## LUCARI INVESTMENTS: BUILDING IMPROVEMENTS JSP18-03

Consideration at the request of Lucari Investments for Preliminary Site Plan and Storm Water Management plan approval for expansion of existing legal non-conforming structure. The subject property contains 3.12 acres and is located in Section 23, on the North side of Ten Mile road, west of railroad tracks. The applicant is proposing to remove a part the front portion, and replacing it with slightly larger addition. The proposed addition results in a net increase of 957 square feet to the existing building of 5,129 square feet. The existing building is a legal non-conforming building as it does not conform to the setback requirements. There are no changes to the parking lot proposed. Few landscape enhancements are proposed.

# PLAN REVIEW CENTER REPORT

## Planning Review

**DIMENSION PLAN**  
 42900 TEN MILE ROAD BUILDING ADDITION  
 PART OF SW 1/4, SEC. 23, T1N-R8E  
 CITY OF NOVI, OAKLAND COUNTY, MICHIGAN

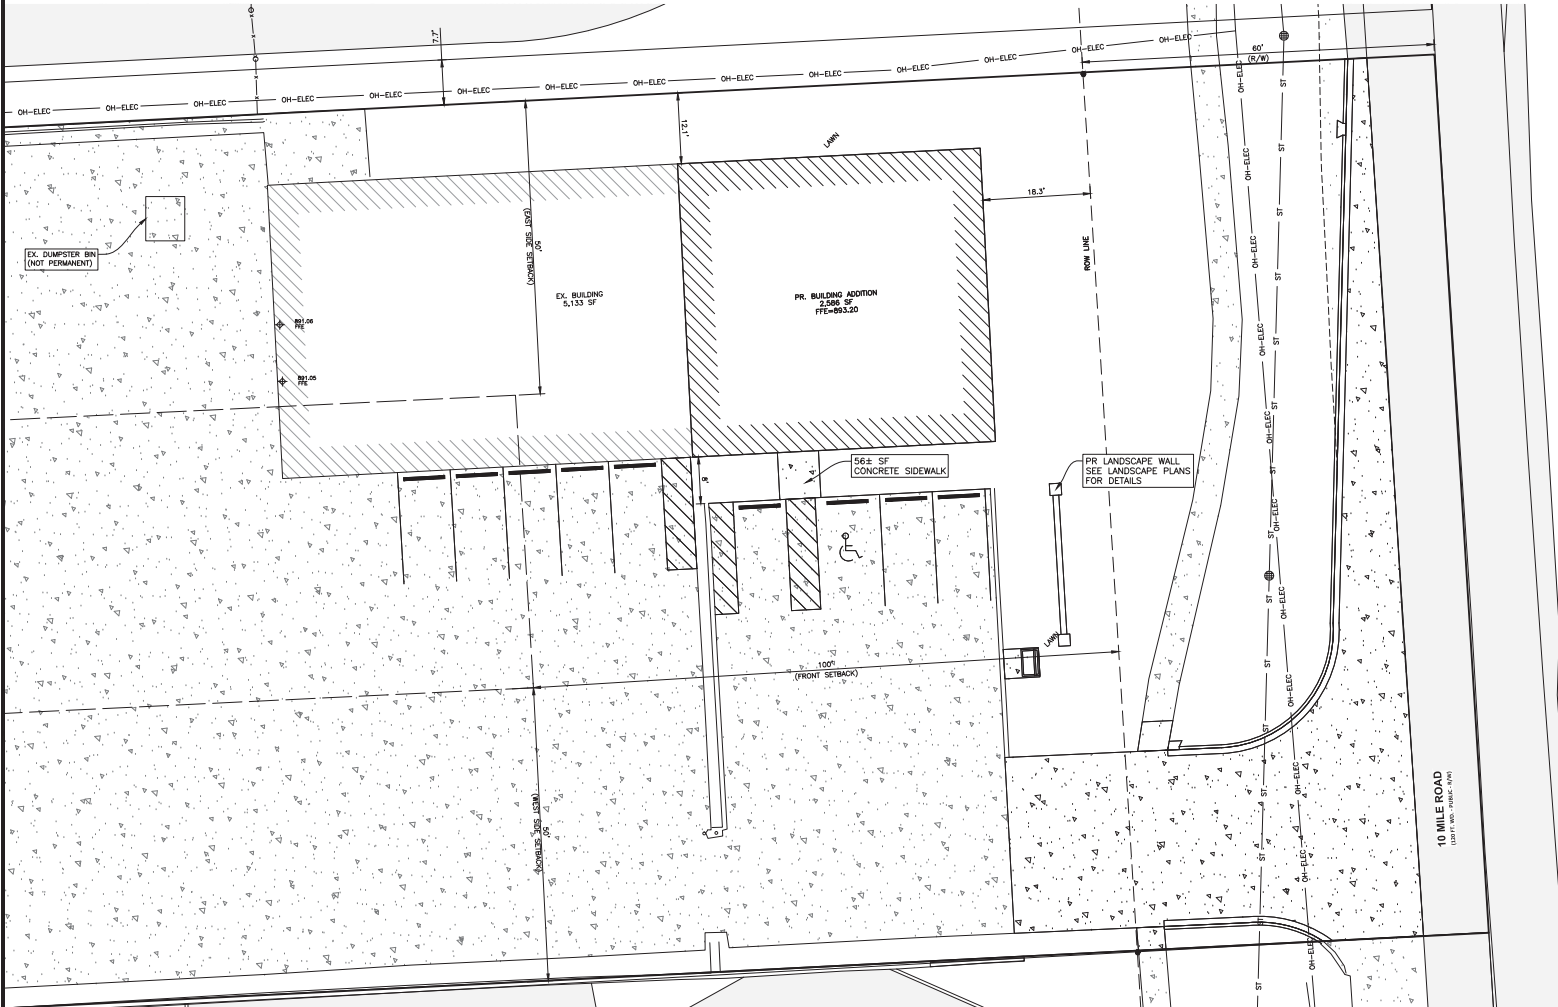
5. Engineering Review: Please address the following comments at the time of Electronic stamping set submittal.
  - a. Remove concrete pavement section detail on Sheet C 1.0
  - b. Please clarify the scope of work. It is staff's understanding that changes to entry driveway are part of phase 2 site plan which was submitted under separate cover. Please clarify the scope of work in this plan set by making the pavement and curb shading and line types consistent with

**GRADING & SESC PLAN**  
 42900 TEN MILE ROAD SITE IMPROVEMENTS  
 PART OF SW 1/4, SEC. 23, T1N-R8E  
 CITY OF NOVI, OAKLAND COUNTY, MICHIGAN

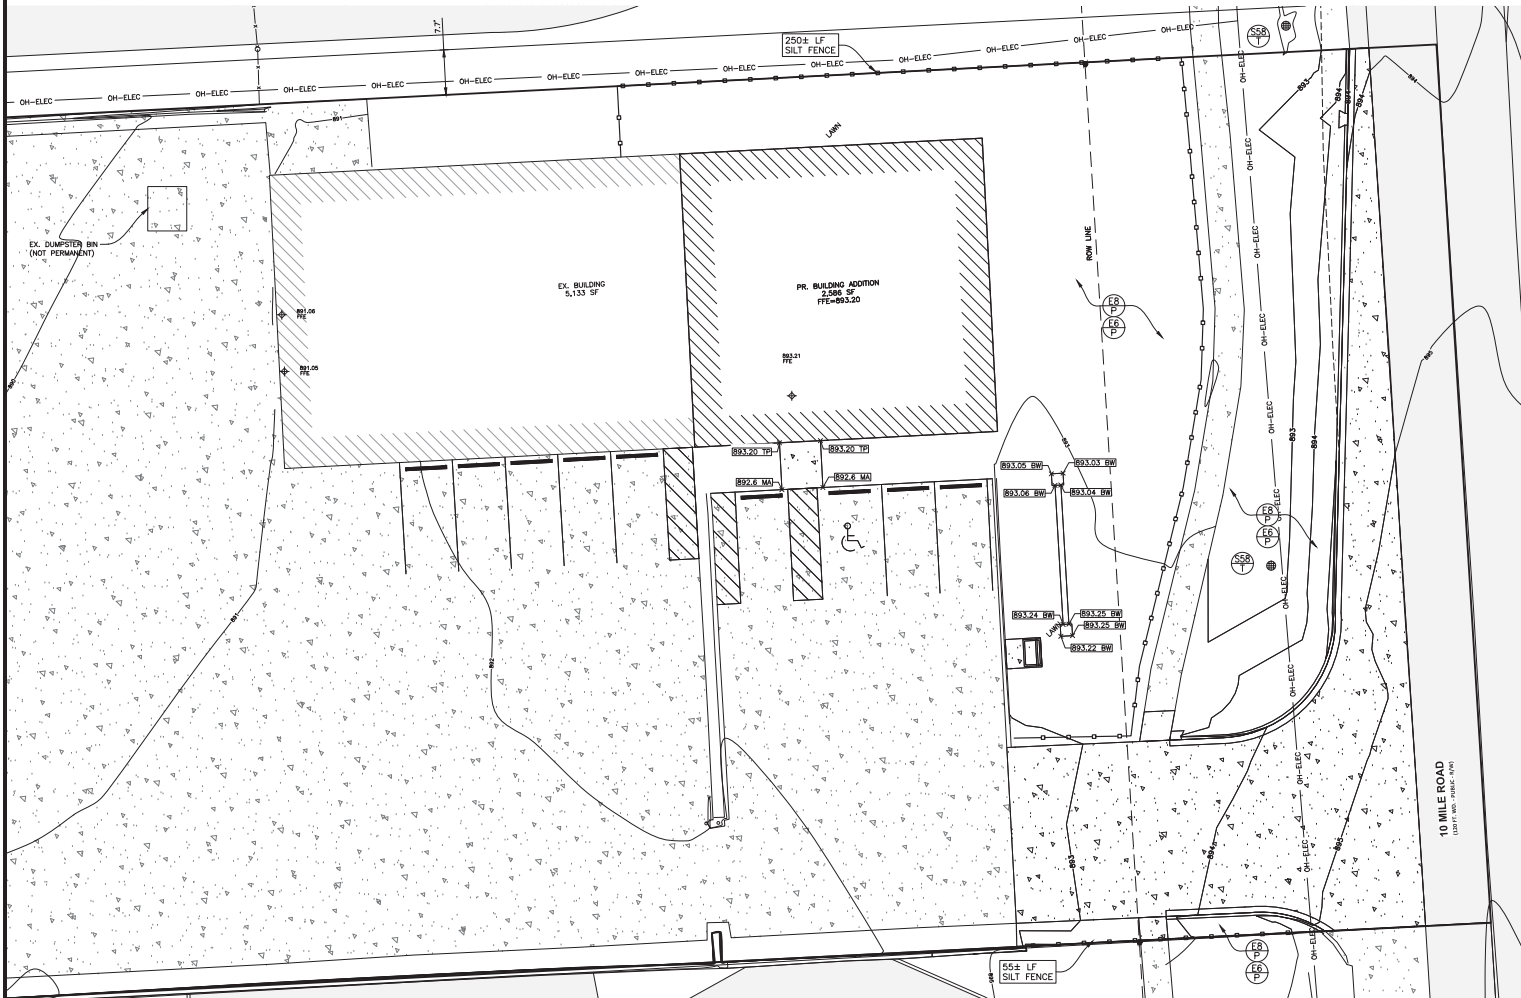
- e. Add a note indicating pre and post impervious square footages on Sheet 7. Note that existing and proposed storm water management is within the regional detention basin area. Contact Darcy Rechten at 248-735-5695 if you have any further questions.

- e. The pre and post impervious areas shall be added to Sheet 7 along with a note about the storm water management systems
  - f. Noted
6. Other Reviews: Noted
